COUNTY OF SAN DIEGO
DEPARTMENT OF PLANNING AND LAND
USE
BUILDING DIVISION

SUPPLEMENTAL CORRECTION LIST – No. 10
Non-Residential Accessibility Regulations

Public Telephones

FIGURE 11B-5A—MINIMUM CLEAR FLOOR SPACE FOR WHEELCHAIRS

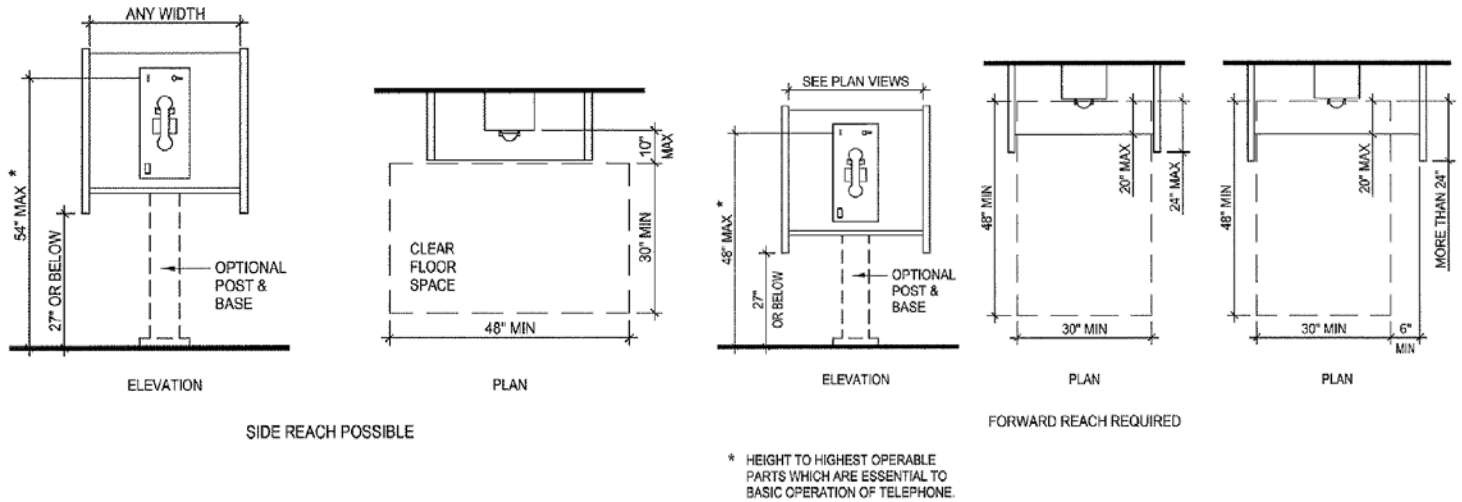
3. One full unobstructed side of the clear floor or ground space for a wheelchair shall adjoin another wheelchair clear floor space. If a clear floor space is located in an alcove or otherwise confined on all or part of three sides, additional maneuvering clearances shall be provided as shown in Figure 11B-5A.
CBC Sec. 1117B.2.4
